Access Compliance Report

Public Rights-of-Way

Intersection ID: 21067	Main Street: BASS_LN	Cross Street: SHADOWSTONE_DR	Location: W
ADA ID: F09A4149A422	Ramp Type: BlendTrans2	Initial Pass/Fail: Pass	Overall Compliance: No
Severity Score: 7.75			
Codes/Mitigation Info/Possible Solution		Field Measurements/Component Compliance

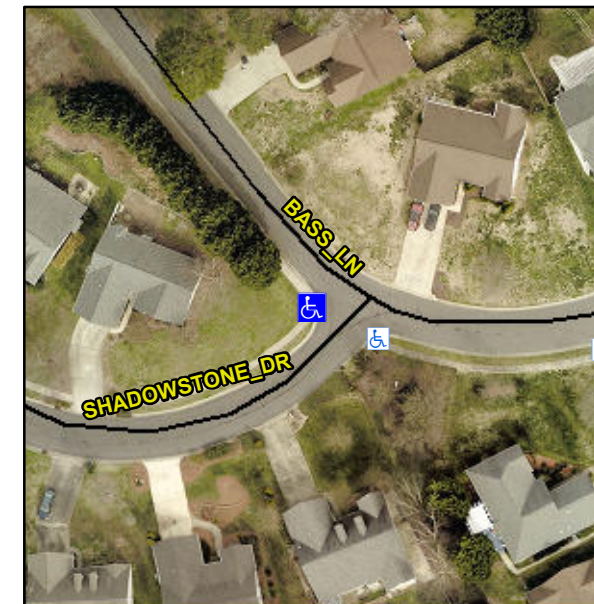
Not Found, R304.5.3, R305.1.4, R305.2, R304.5.4

Compliance	Description	Data	Compliance	Description	Data
N/A	Ramp Length (in)	69.0	Yes	BlendTrans Slope (%)	4.1
Yes	Ramp Width (in)	48.0	No	BlendTrans XSlope (%)	3.1
N/A	Flare Type LT	None	N/A	Flare Type RT	None
N/A	Flare Slope LT (%)	N/A	N/A	Flare Slope RT (%)	N/A
N/A	Flare Traversable LT?	N/A	N/A	Flare Traversable RT?	N/A
N/A	Landing Length (in)	N/A	Yes	DWS Provided?	Yes
N/A	Landing Width (in)	N/A	Yes	DWS Contrast?	Yes
N/A	Landing Slope (%)	N/A	Yes	DWS Length (in)	24.0
N/A	Landing X Slope (%)	N/A	No	DWS Full Width?	No
N/A	Landing Curb? (Y/N)	No	No	DWS Offset (in)	6.0
N/A	Shared Landing?	No			
Yes	Gutter Ponding?	No	No	Gutter Slope (%)	9.8
Yes	Gutter Lip Ht (in)	0.0	No	Gutter X Slope (%)	3.6
N/A	Painted X Walk1?	No	N/A	Painted X Walk2?	No
	X Walk 1 Direction	To SE		X Walk 2 Direction	To NE
	X Walk 1 Width (in)	N/A		X Walk 2 Width (in)	N/A
	X Walk 1 Slope (%)	1.6		X Walk 2 Slope (%)	2.0
	X Walk 1 X Slope (%)	4.0		X Walk 2 X Slope (%)	0.2

N/A	Ramp inside XWalk1?	N/A	N/A	Ramp inside XWalk2?	N/A
	Road Slope (%)	4.7		Clear Space?	Yes
	Road X Slope (%)	5.1	N/A	Clear Space to XWalk (in)	N/A
Yes	Any Obstructions?	No	Yes	Storm Grate/Utility Hazard?	No
	Obstruction Type			Storm Grate/Utility Type	
		N/A			N/A
			Yes	Surface Condition? (G/P)	Good
			No	Curb Slope (%)	8.1

Remove & Replace Curb Ramp With Two New Directional Ramps or Equivalent. Remove & Replace Gutter.
